### 22-193728-REV-01-MI

### Permit Revision Submittal Requirements and Application

Manufactured Home Relocation 9742 SE Woodstock Ct., Portland OR 97266

## Site Development Checksheet Response #3 Attn: JED STOKEN, PE

SHEET INFO		
	SHEET TITLE: Foundation Plan		
>	DATE: 10-11-2022	REV 1 05-30-2023	$\mid \cdot \rangle$
	SCALE: 1/4" = 1'-0"	REV 2 06-26-2023	
	SHEET: 5 OF 8	REV 3 09-11-2023	
(			-

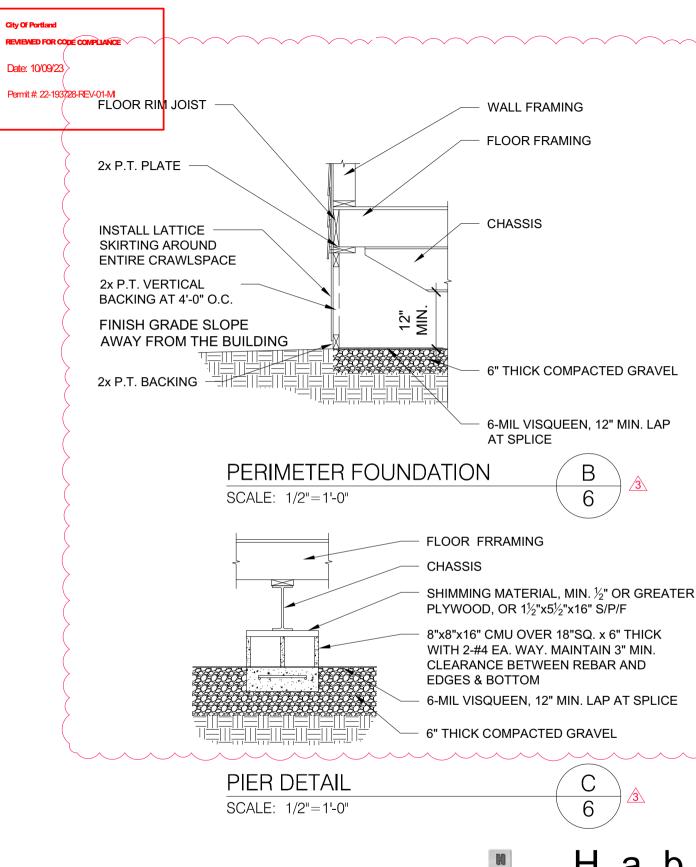
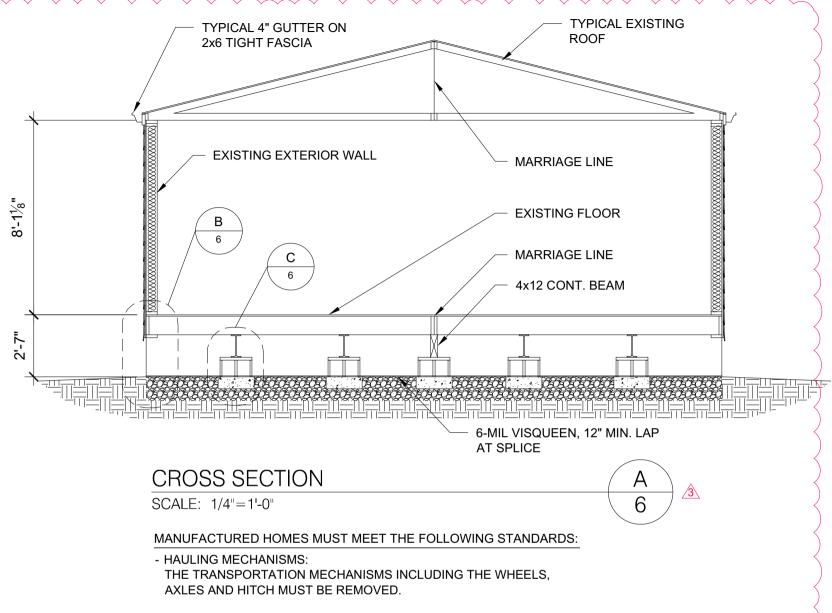
Minimum Submittal Requirements (check all box	xes and sign below):	
■ A copy of this application.		
☐ One PDF copy of plans for electronic submittals or	three copies for paper submittals.	
☐ All plans must clearly reflect the proposed change	(s). Changes must be bubbled.	
	igned by the Architect and/or the Engineer of Record, if applicable.	
☐ Project narrative for extensive revisions.	,	
	locuments for electronic submittals or two copies for paper submittals.	
submittals and two copies for paper submittals.	n is due to an inspection correction. One PDF copy for electronic	
Applicant Information:		
Applicant Name Maria Adrian		
Street Address 229 NW 7t hSt	City/State/ZIP McMinnville, 97128	
Email maria_adrian@hotmail.com	Phone 503-318-1257	
Value of Proposed Revision 0	Issued Permit # 22-193728	
Job Site Address 9742 SE Woodstock Ct	City/State/ZIP Portland, 97266	
foundation.	rel pad with block piers and earthquake anchors not perimeter

- FOUNDATION. THE MANUFACTURED HOME MUST BE SET ON A PERIMETER FOUNDATION AS SHOWN ON PAGE 5.
- INSTALL AND CONNECT MANUFACTURED HOME SUB-FRAME TO FOUNDATION PER MANUFACTURER'S SPECIFICATIONS AND RECOMMENDATION.

SHEET INFO	PROJECT
SHEET TITLE: Project Information	Manufactured Home Relocation
DATE: 10-11-2022 REV 1 05-30-2023	9742 SE Woodstock Ct., Portland OR 97266
SCALE: N/A REV 🖄	
SHEET: 1 OF 8 REV (3) 09-22-2023	Owner: Marie Adrian

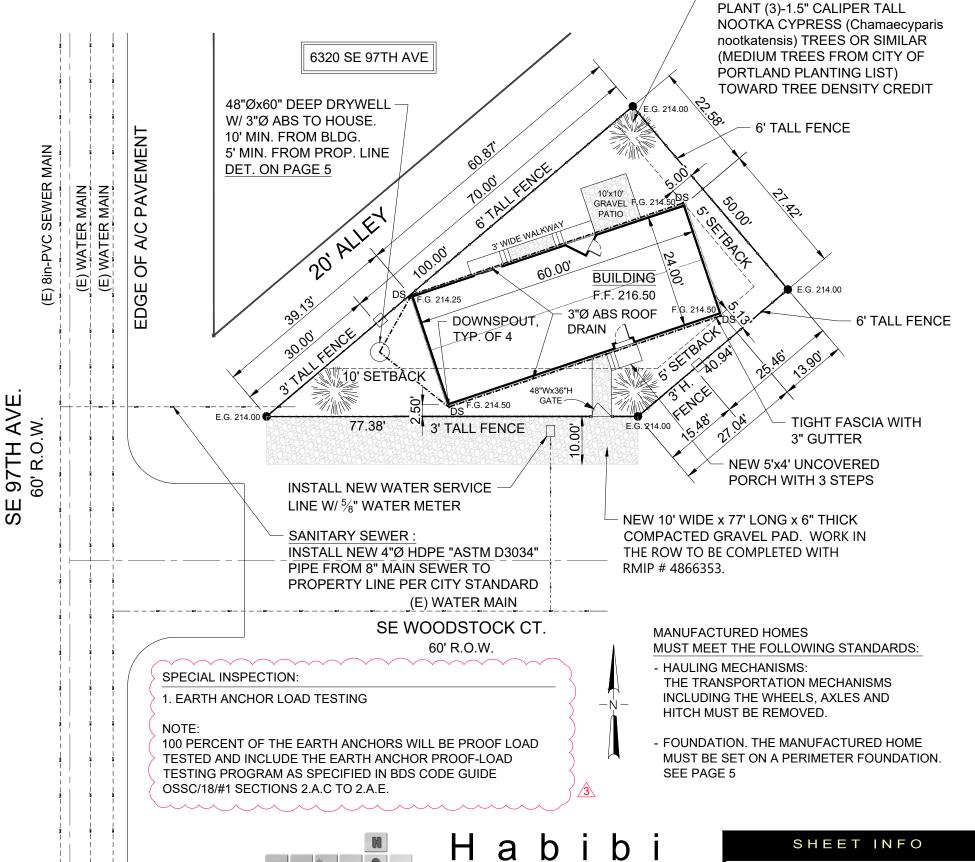
Permit #: <u>22</u>	-193728-REV-01-MI Date: 09-22-2023	
Customer na	me and phone number: Maria Adrian, 503-318-1257	
change	e number each change in the '#' column. Use as many lines as nece es. Indicate which reviewer's checksheet you are responding to and es. If the item is not in response to a checksheet, write customer in	I the item your change ad-
#	Description of changes, revisions, additions, etc.	Location On plan
1	Please see attached filled out special inspection form	Attached
2	Please see pages 1 and 2 for added special inspection notes	1 & 2
3	Please see pages 1 and 2 for added special inspection notes	1 & 2

100 PERCENT OF THE EARTH ANCHORS WILL BE PROOF LOAD TESTED AND INCLUDE THE EARTH ANCHOR PROOF-LOAD TESTING PROGRAM AS SPECIFIED IN BDS CODE GUIDE OSSC/18/#1 SECTIONS 2.A.C TO 2.A.E.
